**FINAL DRAFT  
REPORT**

**Clarksburg - Ten Mile Creek Area  
Sewer Facility Study**

Washington Suburban  
Sanitary Commission

March 2, 2015

**Figure 4-2**  
**Comparison of Pump Station Sizes**

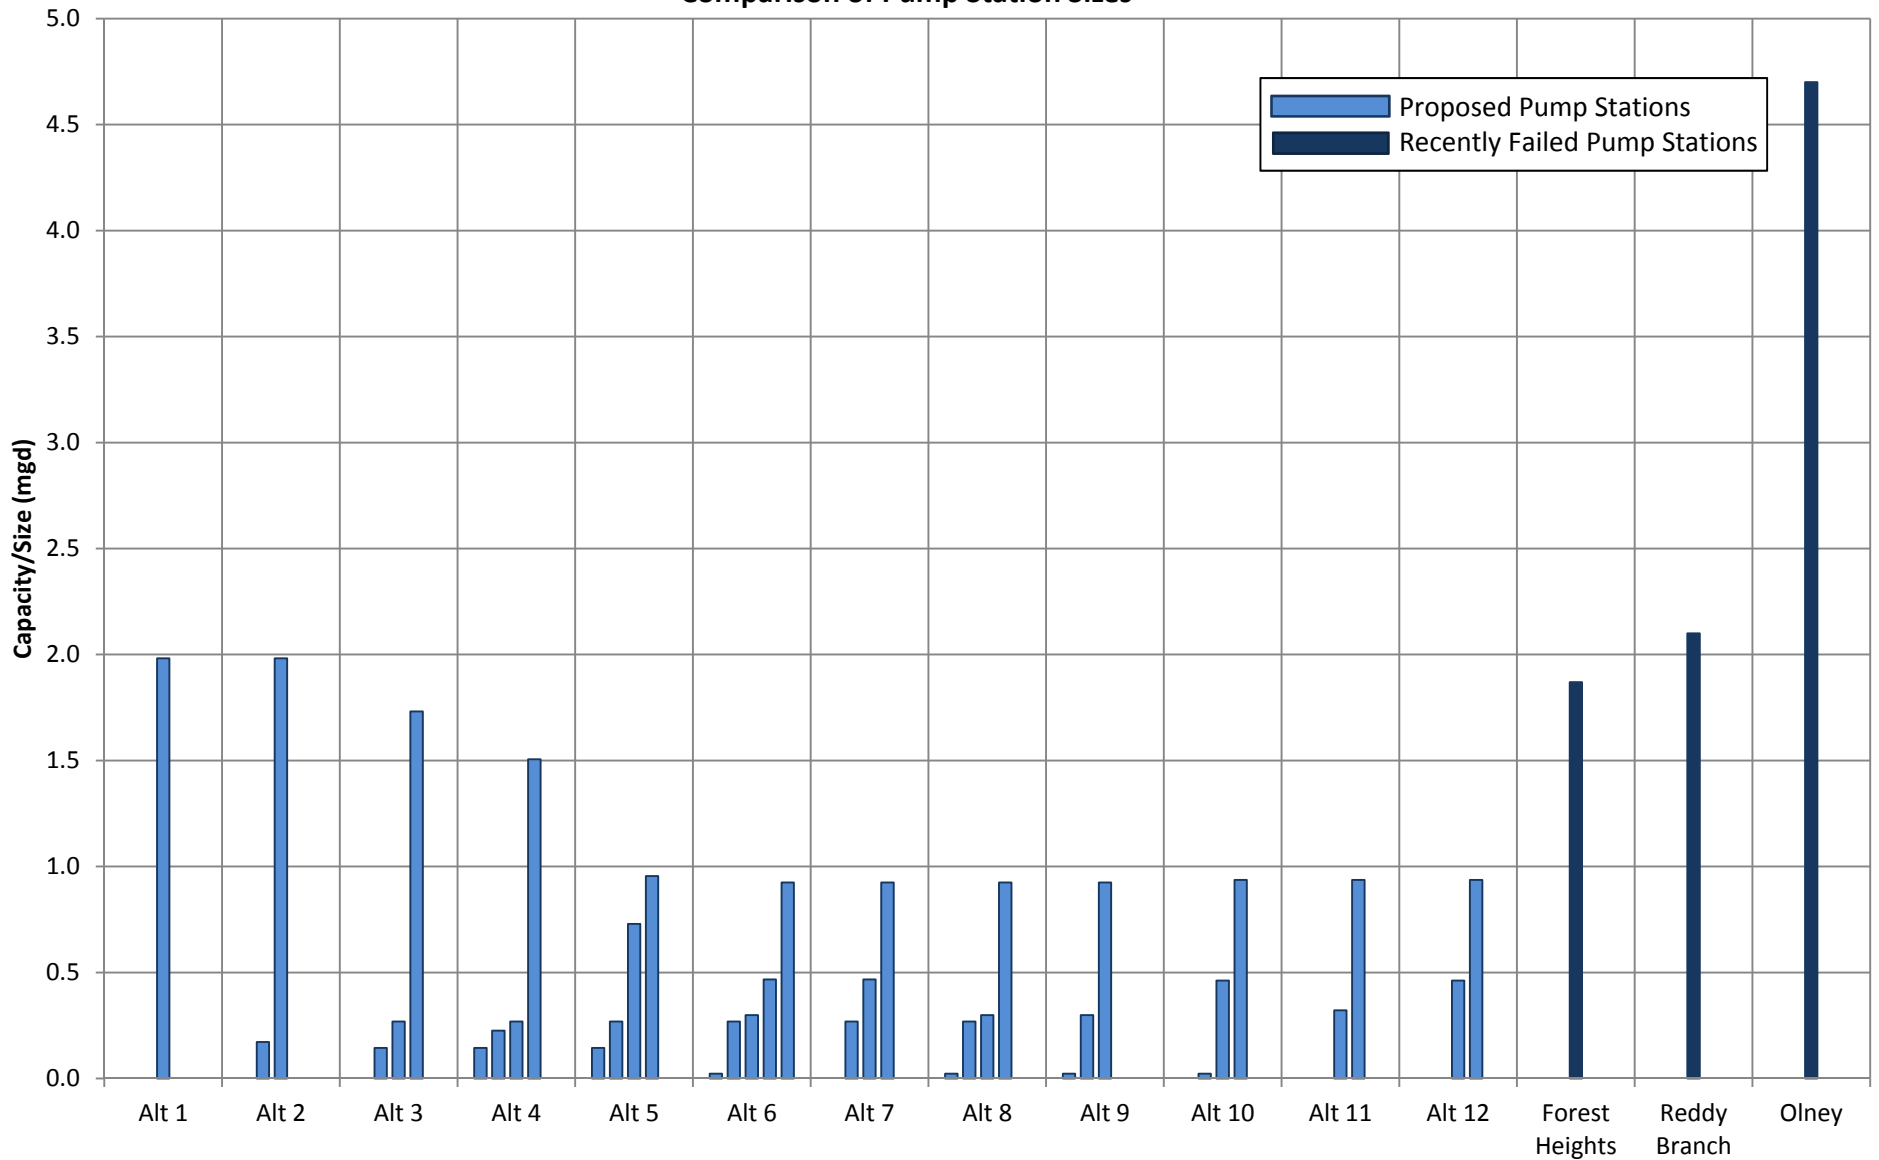
2	12/21/2015	Katherine E. Nelson Planner Coordinator M-NCPPC	<i>11. Figure 4-1 and 4-2 pages 4-14 and 4-15 – Should identify “recently failed” pump stations rather than “existing” pump stations. It implies that these are the only pump stations in the WSSC system.</i>	Revised figures 4-1 and 4-2 in the Final Draft Report to address the comment.
53	12/21/2015	Katherine E. Nelson Planner Coordinator M-NCPPC	<i>12. Figure 4-3 and 4-4 (the Preferred Approaches) – The graphics reference “Grinder Systems” and “grinder pump solution”, but the legend identifies “Low Pressure Sewer”. One term should be used when describing these systems, both on these graphics and in the text.</i>	Revised figures in the Final Draft Report to address the comment.
54	12/21/2015	Katherine E. Nelson Planner Coordinator M-NCPPC	<i>13. Criteria for the successful use of low pressure sewers should be provided by this study. At a minimum, examples of the successful use of low pressure sewers should be provided.</i>	Refer to WSSC SP ENG-04-10, Grinder Systems Policy and Procedure, as to successes we have achieved based on experience and meeting policy requirements.
